SUBJECT: WAILUKU-KAHULUI WWRF ADDITIONS AND MODIFICATIONS
NEGATIVE DECLARATION

ENVIRONMENTAL ASSESSMENT
AND
NEGATIVE DECLARATION

~~W~~WAILUKU-KAHULUI WASTEWATER RECLAMATION FACILITIES
ADDITIONS AND MODIFICATIONS ~~*~~

BROWN AND CALDWELL
CONSULTANTS

BY DATE APP. 	DEPARTMENT OF PUBLIC WORKS COUNTY OF MAUI, HAWAII	GENERAL Figure 5 EAST SITE PLAN	SCALE 1" = 60'
	WALUKU-KAHULUI WASTEWATER RECLAMATION FACILITIES ADDITIONS AND MODIFICATIONS		DRAWING NUMBER
			SHEET NUMBER 8

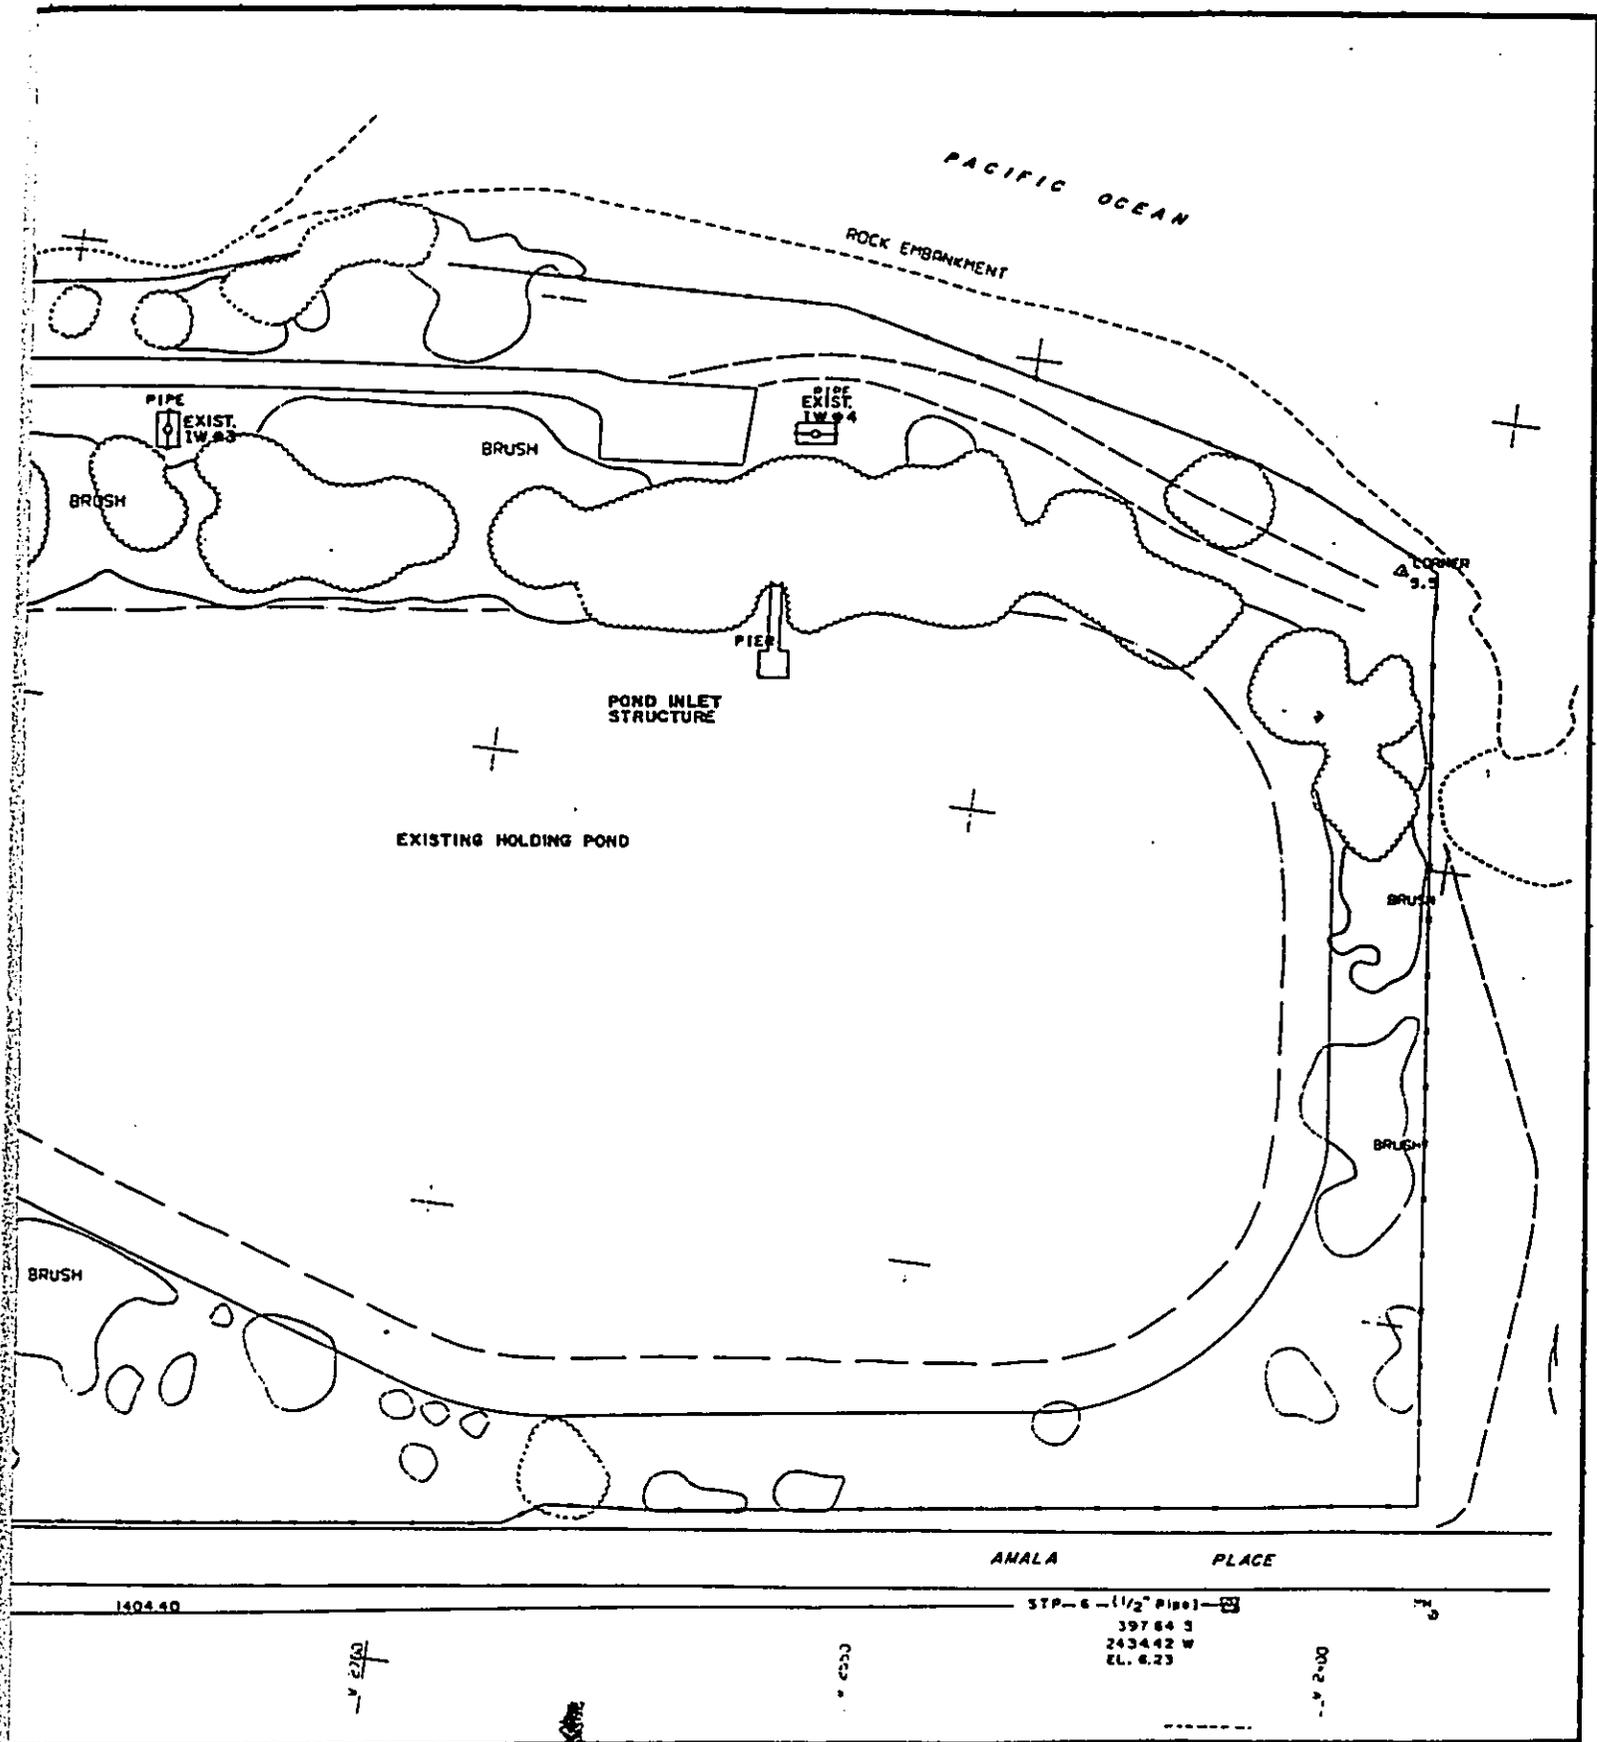
c. The rock embankment shown in the East Site Plan (Figure 5) is a Federally-constructed shoreline protection project. Any proposed improvements affecting the shoreline protection project must be coordinated with the Corps of Engineers. For further information, please contact Planning Division at 438-8880.
